Re: West Edge Subdivision  
Aberdeen, SD  
Helms A-8668

**ADDENDUM NUMBER 1**

The following modifications are made to the plans and specifications for the West Edge Subdivision, Aberdeen, SD.

MODIFIED TYPE "M" 24 CONCRETE CURB AND GUTTER DETAIL  
NO SCALE

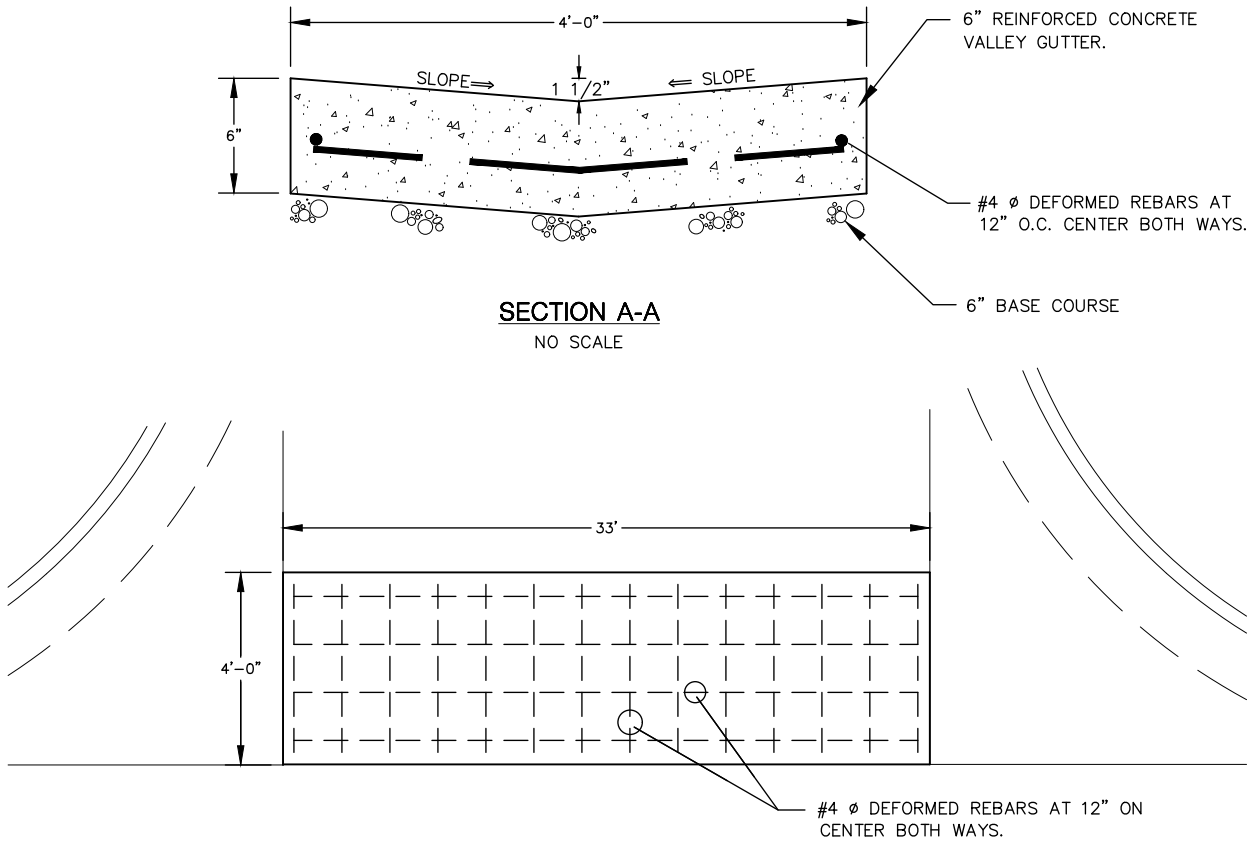
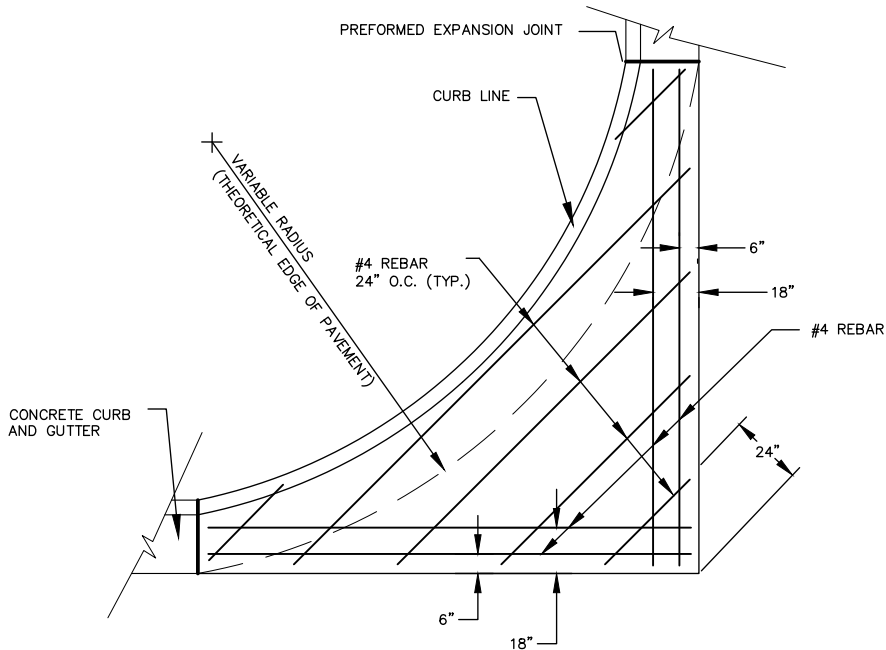
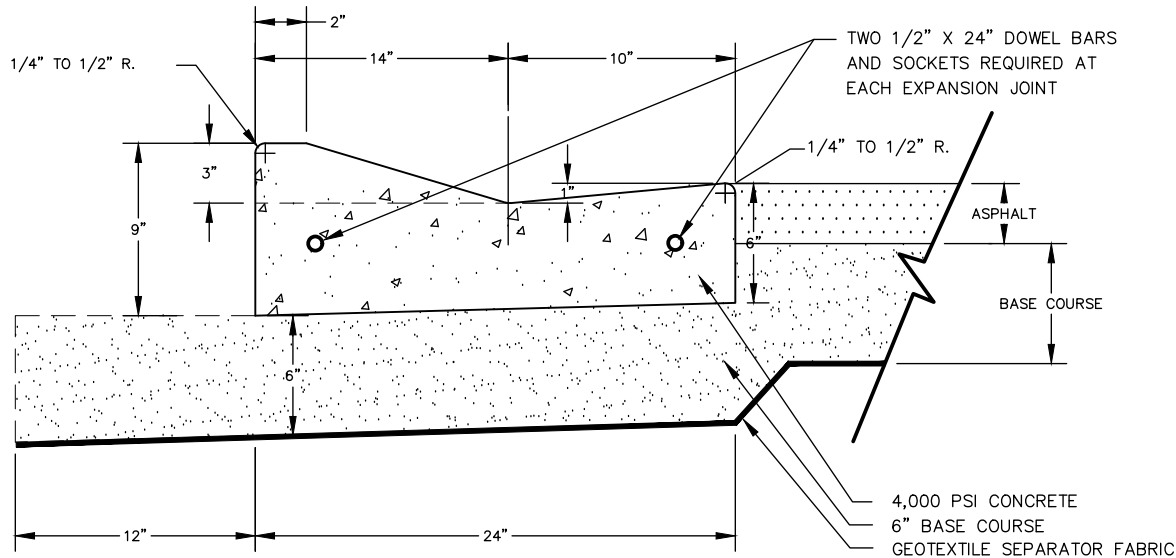
**6.) Construction Plan Sheets: Sheet 51 of 109. Curb and Gutter Detail Revision. Remove and replace with the attached.**

63  
OF  
109

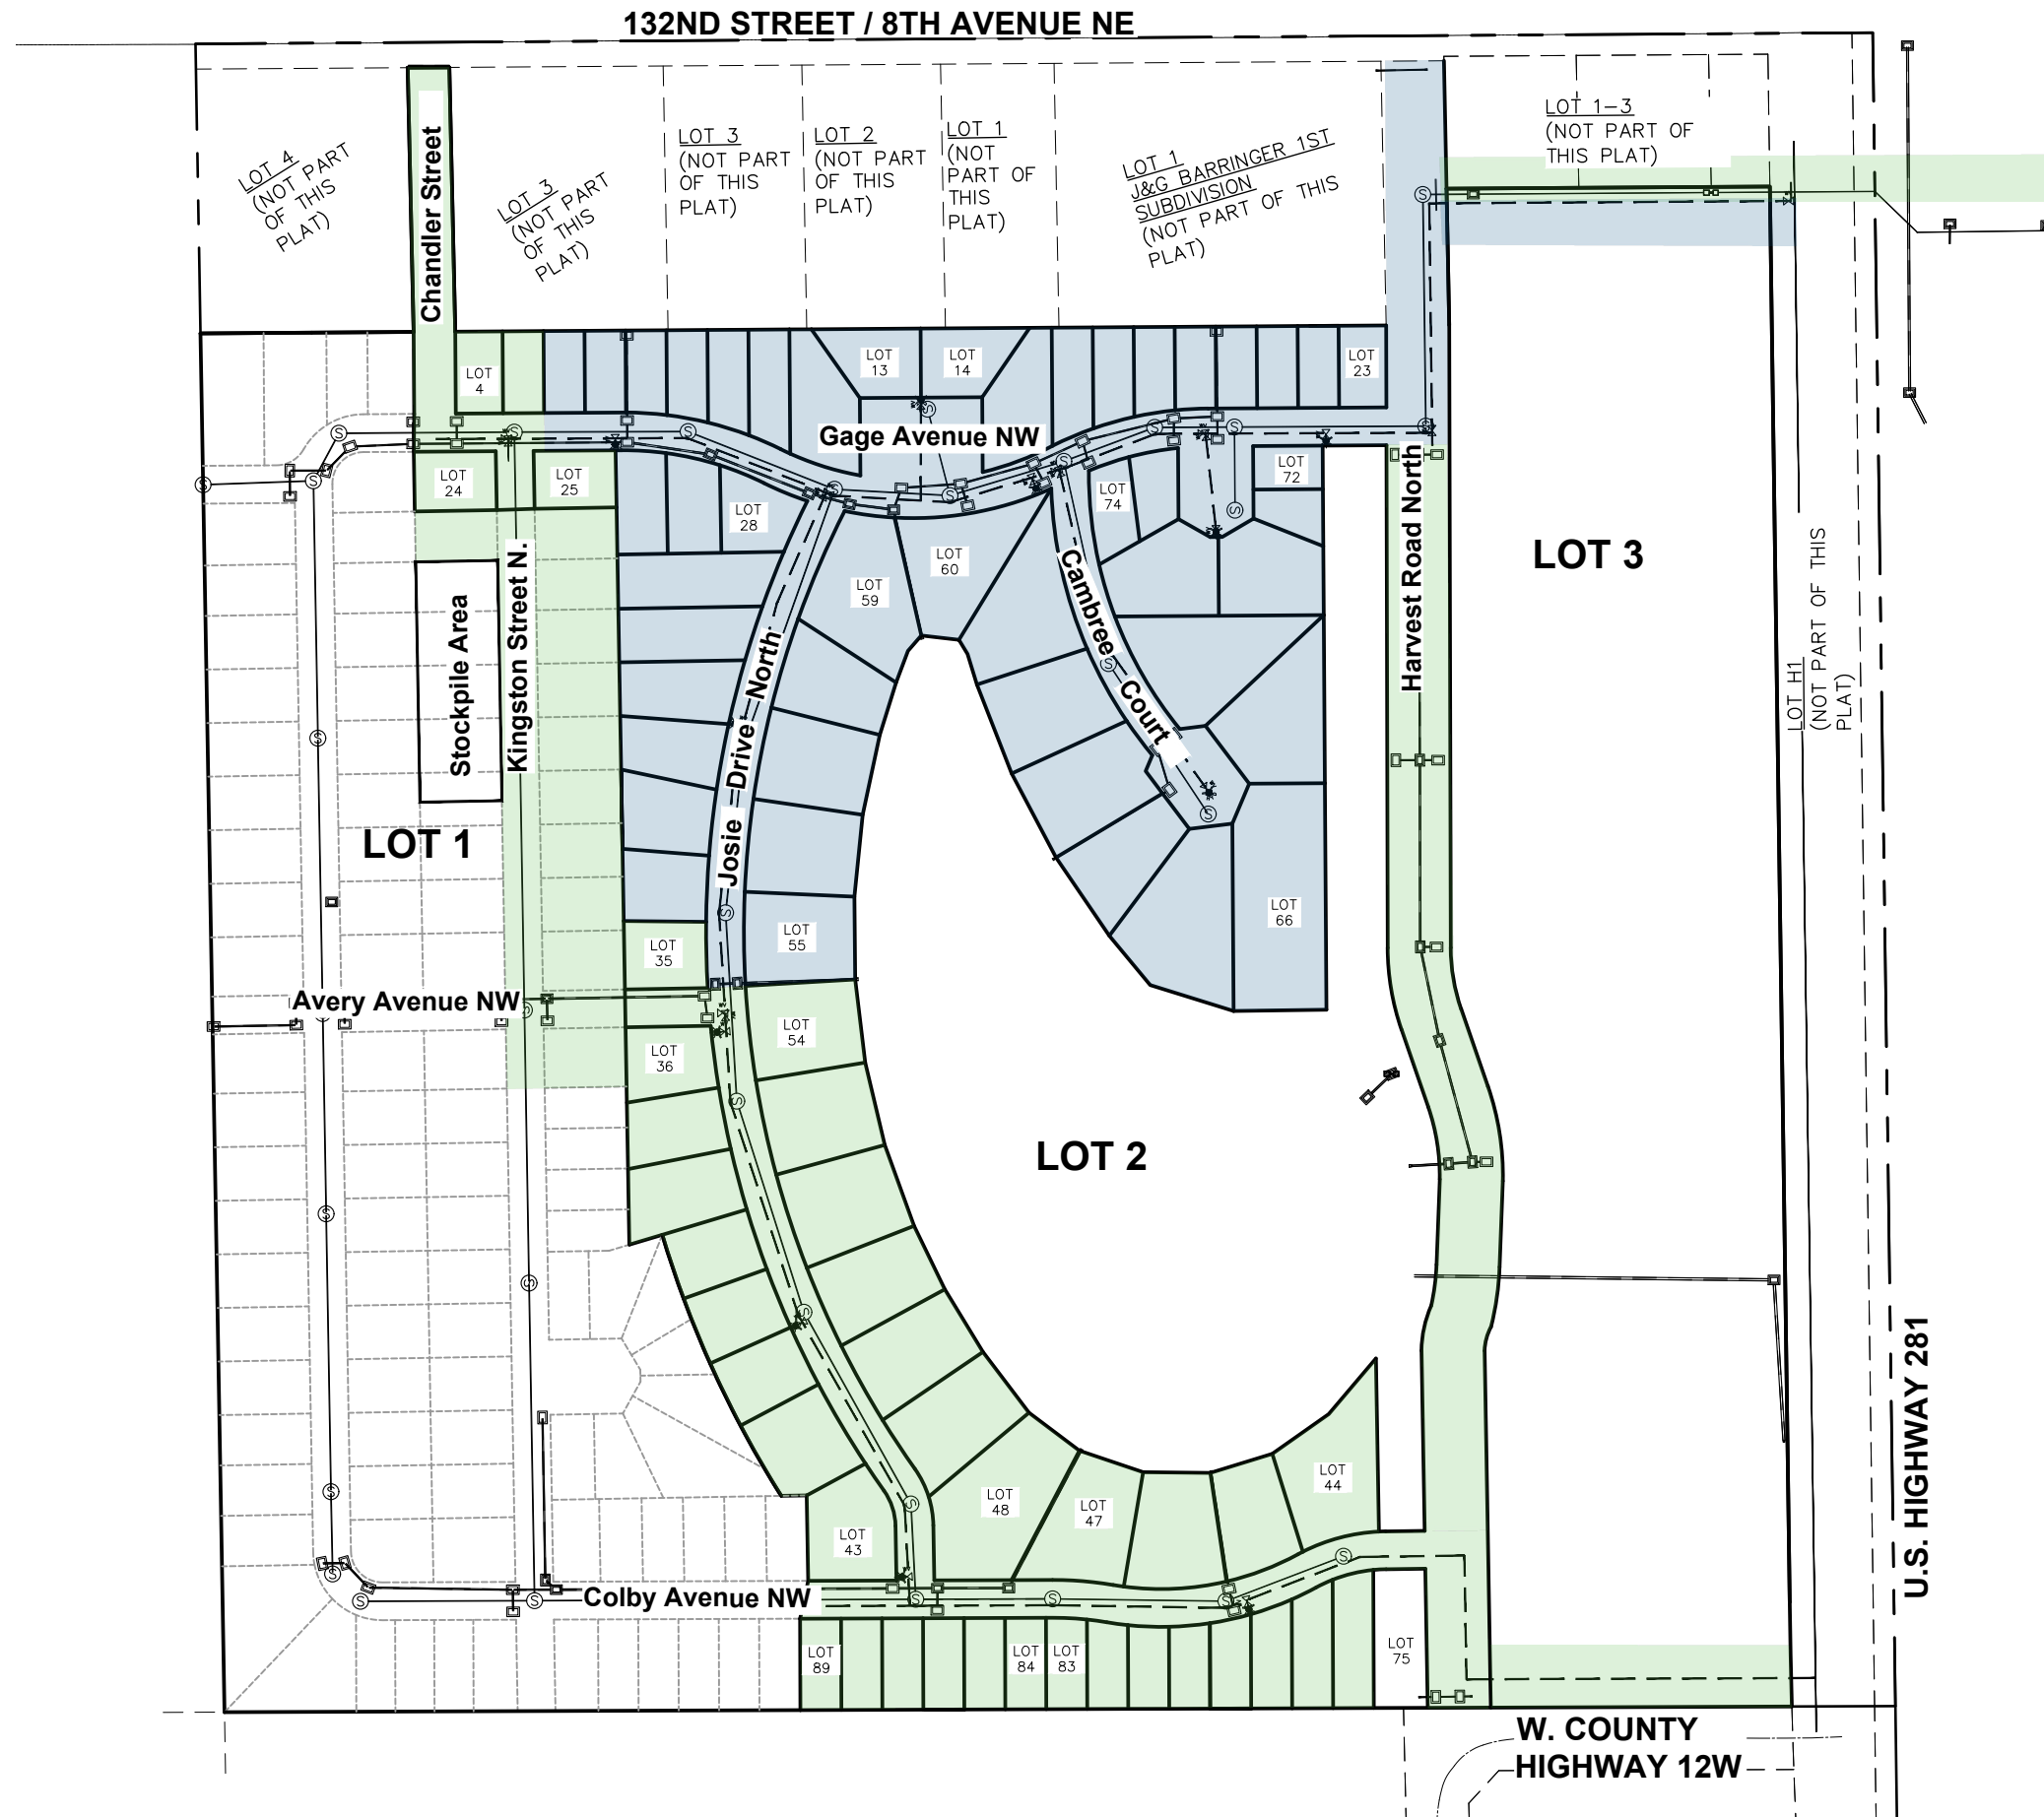
**7.) Construction Plan Sheets: Sheet 63 of 109. Construction Phasing Plan Revision. Remove and replace with the attached.**

CONTRACTOR SHALL HAUL  
EQUIPMENT AND MATERIAL FROM  
THE NORTH. THE CONTRACTOR  
WILL TAKE PRECAUTIONS TO  
NOT USE OR HAUL ACROSS  
PAVED SUBDIVISION STREETS.
